Optimization Review Report Operation and Maintenance Optimization Study

**United Chrome Products Superfund Site
Corvallis, Benton County, Oregon
EPA Region 10**

FINAL REPORT
July 2019

Figure 3: Initial Plume Extent in Upper and Deep Aquifers [Excerpted from 2003 Five-Year Review (EPA, 2003) All figures reproduced in Appendix B.]

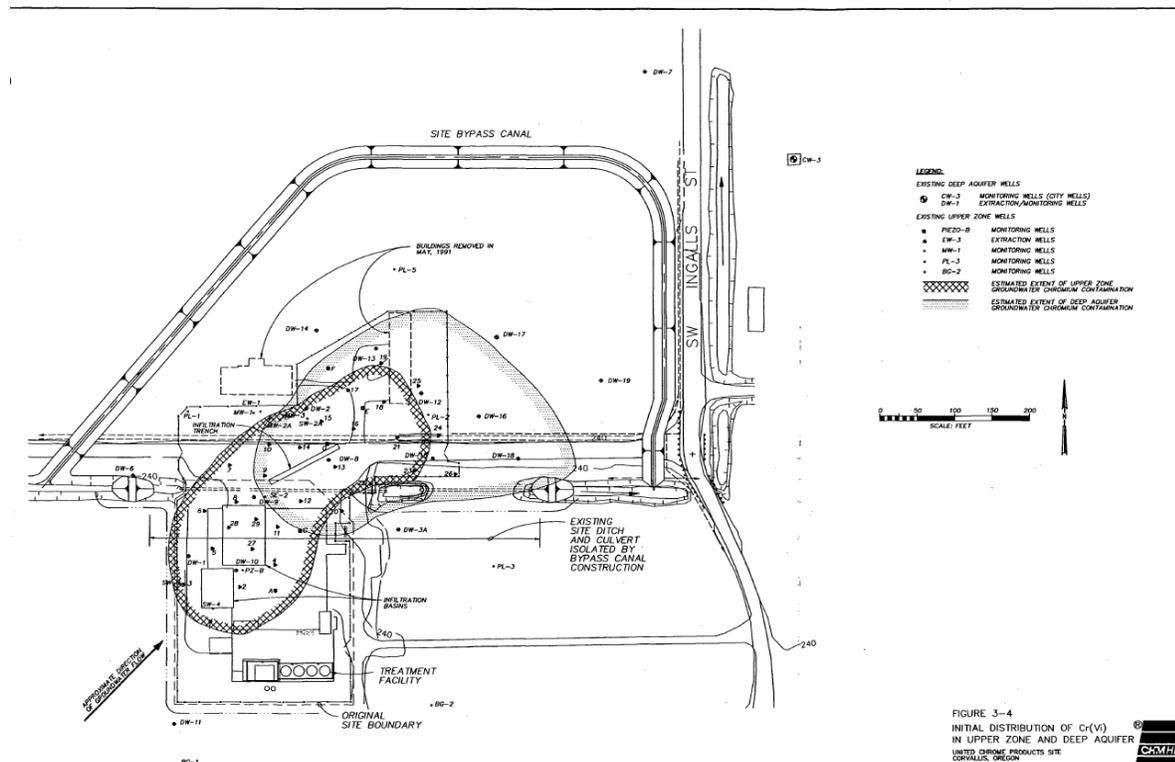
However, while the model was developed to assess attainment of the MCL at the municipal well 3000 ft downgradient from the plant, the ROD requires compliance at the plant boundary, and current EPA groundwater policy is to attain the MCL throughout the Site. Either way, the assumption that attaining a Cr concentration of 6.5 mg/L in the Upper Aquifer would result in attainment in the Lower Aquifer is incorrect. In addition, other assumptions about mobility, dilution and dispersion may not reflect the current understanding of the Site. Given this, the remedial goal in the Upper Aquifer should be reevaluated.

The amount and distribution of residual contamination in the Upper Aquifer and its transport pathways to the Deep Aquifer are priority sources of uncertainty in the CSM.

The optimization team recommends either changing the remedial goal in the Upper Aquifer to the MCL (a conservative approach, given the possibility of even lower future regulatory goals for Cr [VI]) or performing new modeling based on updates to the CSM. The new remedial goal should be protective of the entire Deep Aquifer at the MCL (including the area directly below the plating tanks) and prevent off-Site migration of Cr in the Upper Aquifer above the MCL. EPA should clarify precisely where the remedial goal in the Upper Aquifer must be attained.
